APICAL INDUSTRIES, INC.
dba DART AEROSPACE

ENGINEERING CHANGE NOTICE NO.

DWG NO. 647.7700

DWG TITLE: STRUT ASSY

SHEET 2, ZONE D4 IS:

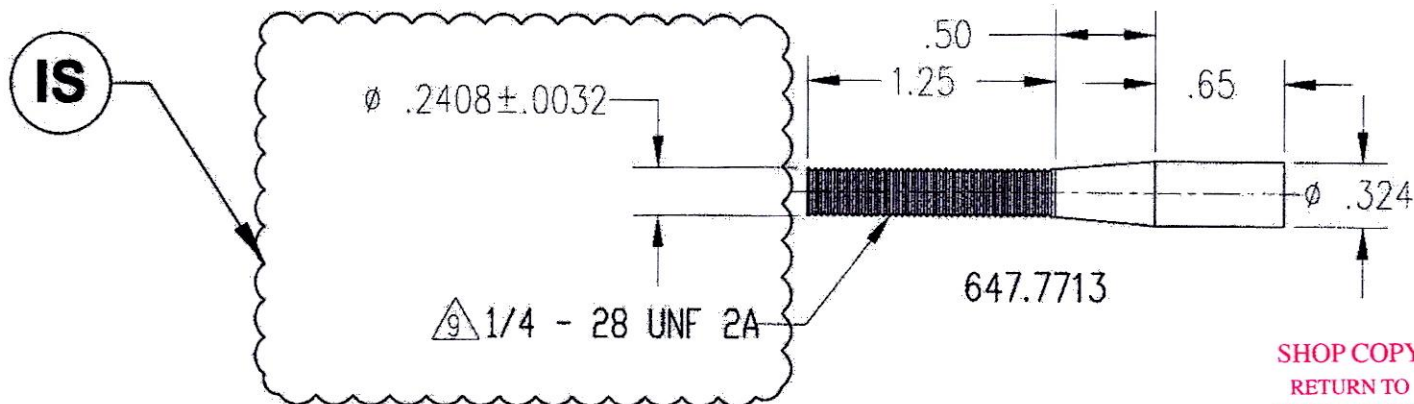
REASON: REVISED DIMENSION

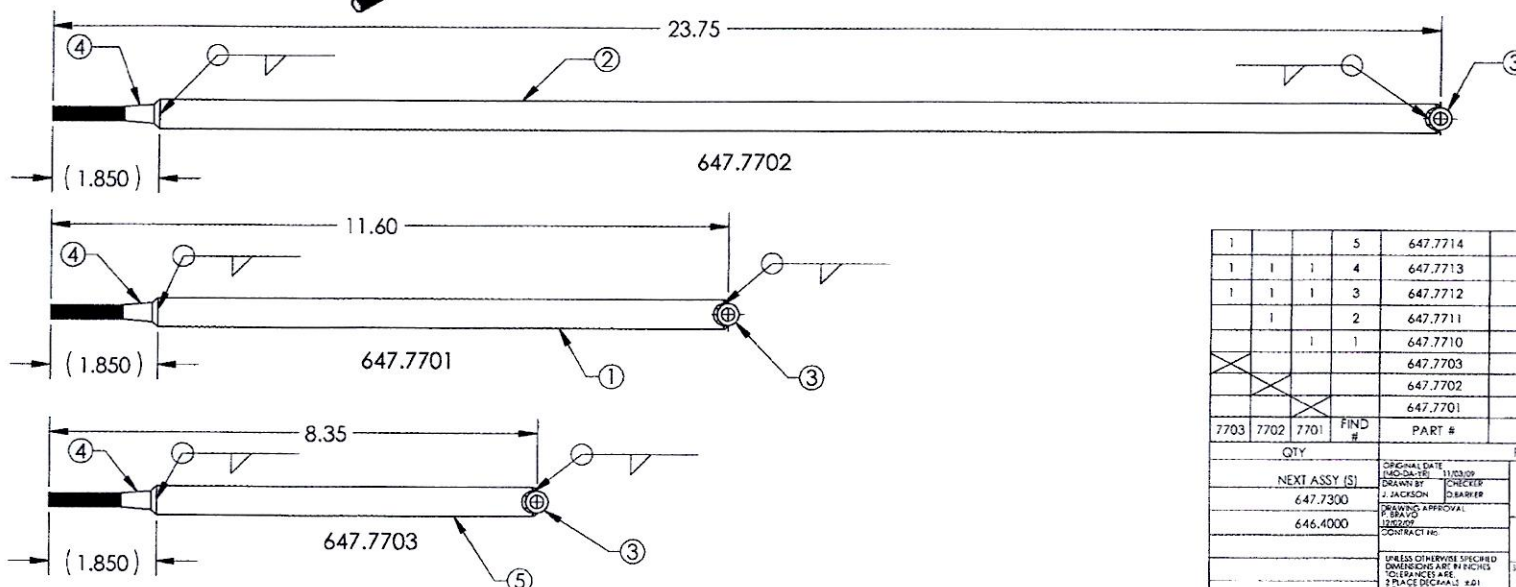
REASON: REVISED FINISH CALLOUT AS PER ECR 15-209

SHEET 1, NOTES IS:

- 1 MATERIAL: 4130 STEEL PER AMS-T-6736, .50" OD, .083" WALL THK.
- 2 MATERIAL: 4130 STEEL PER AMS-T-6736, .375" OD, .075" WALL THK.
- 3 MATERIAL: 4130 STEEL PER AMS-T-6736, .324" OD.
- 4 FINISH: PRIME IAW MIL-P-2337J TYPE I CLASS N; 1-2 MIL MAX
5. DEBURR AND BREAK ALL SHARP EDGES
6. IDENTIFY IAW MPP-120.
- 7 WELD IAW MIL-STD-2219. TIG WELD WITH FILLER ROD
- 8 FINISH: CAD PLATE IAW QQ-P-416F CLASS I TYPE II
- 9 MASK THREAD PRIOR TO FINISH
